December 18, 2023

Subject: **Deficiency of License Application and Additional Information Request
Gile Flowage Storage Reservoir Project (FERC Project No. 15055-001)**

The figures below are water quality profiles immediately above the Gile Dam (location #3) developed from data collected during the 2022 water quality study. The figures are also included in Section 3.4.1.2.3 in Exhibit E of the FLA.

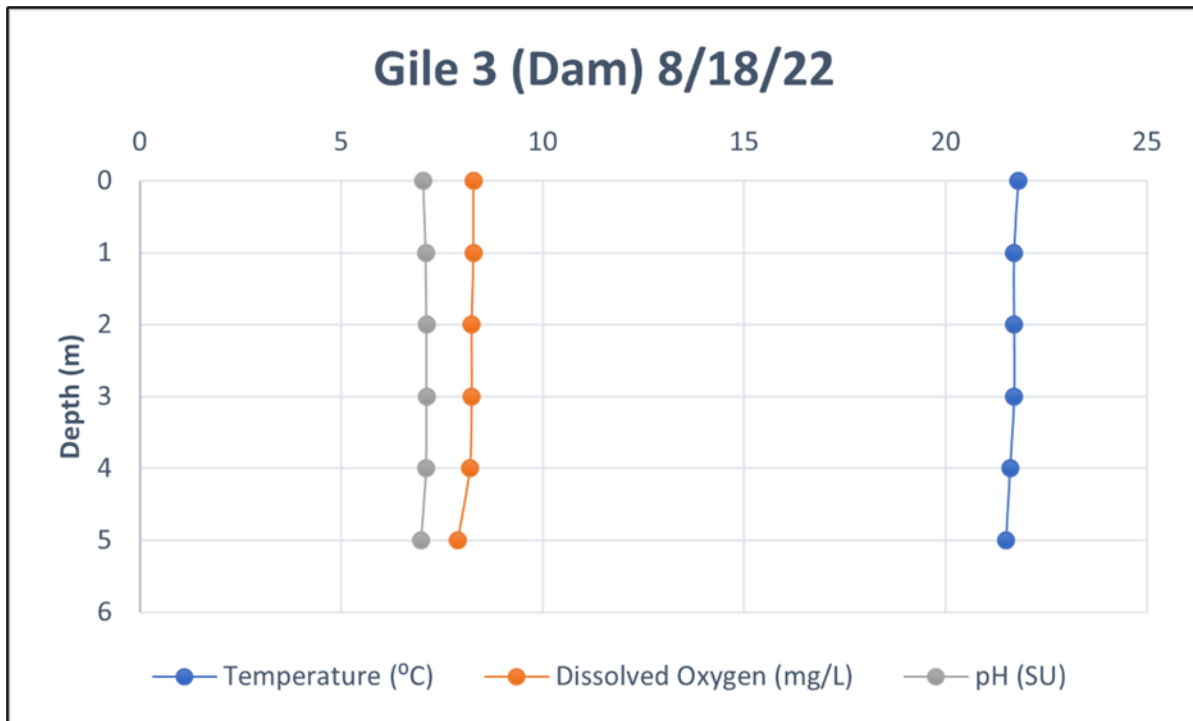
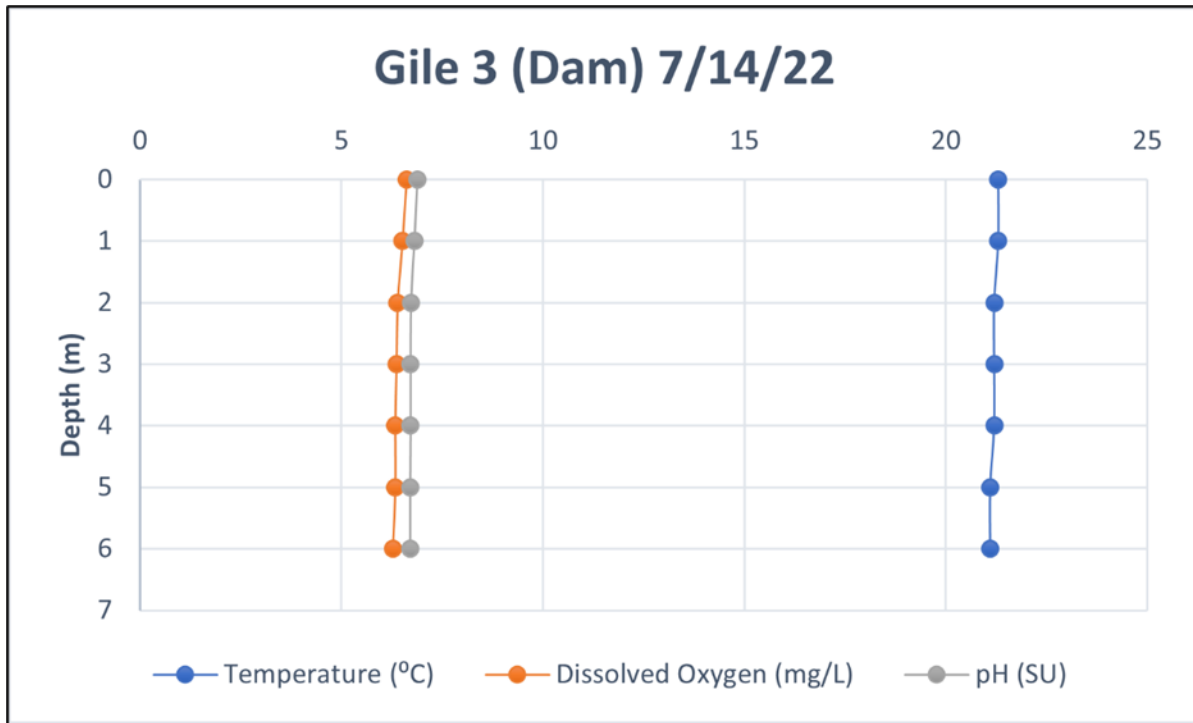
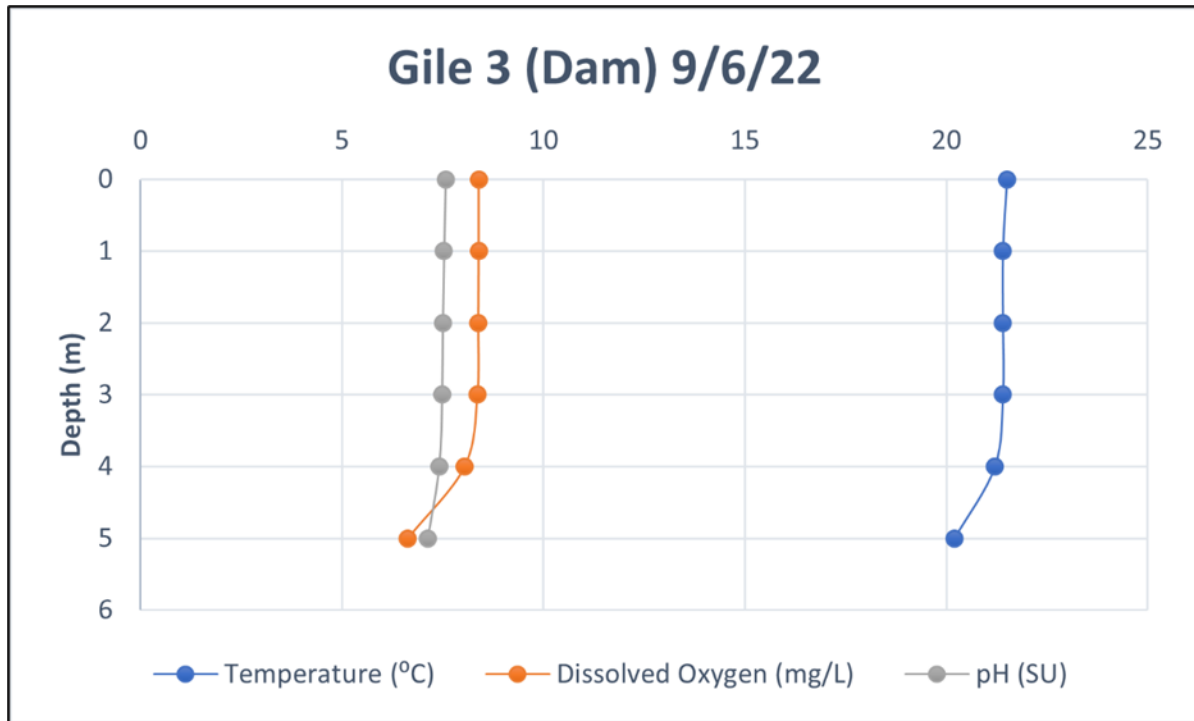
Section 3.5.1.4.3 of Exhibit E states that during the August 30, 2022 Minimum Flow Habitat Evaluation Study (minimum flow study), a flow of 35.25 cfs was passed downstream of the dam through the sluice gate, instead of the assumed discharge of 12 cfs at the minimum gate setting. Section 3.4.1.2.3 of Exhibit E describes a water quality study during which water quality data was collected downstream of the dam on four days between May 18 and September 6, 2022. Appendix E-9 of Exhibit E includes the water quality monitoring study report but does not describe project outflow during data collection. So that staff can better understand the project's minimum flow releases and effects on water quality, please: (1) provide the flows that were being passed downstream during the water quality study, including any changes in flow that occurred during the study (in cfs); and (2) discuss whether the proposed minimum flow release from the sluice gate is 10, 12, or 35.25 cfs; and any potential effects on water quality associated with these flow releases.

The downstream water quality monitoring was conducted on May 18, July 13, August 18, and September 6, 2022. The water released from the Project during said dates is shown in the following table (no changes to flow were made during the monitoring).

The sill of the sluice gate is at elevation of 1,465.5 feet NGVD. On the profile figures shown above, the bottom sill of the sluice gate is the bottom of the profile taken. The reservoir does not stratify and the lowest dissolved oxygen readings in the profiles are greater than the Wisconsin dissolved oxygen standard of 5 mg/L. Water temperatures are also within Wisconsin water temperature standards. Therefore, reducing the minimum flow to 10 cfs, as proposed by NSPW in the FLA, is not expected to lower dissolved oxygen levels below the Wisconsin water quality standards.
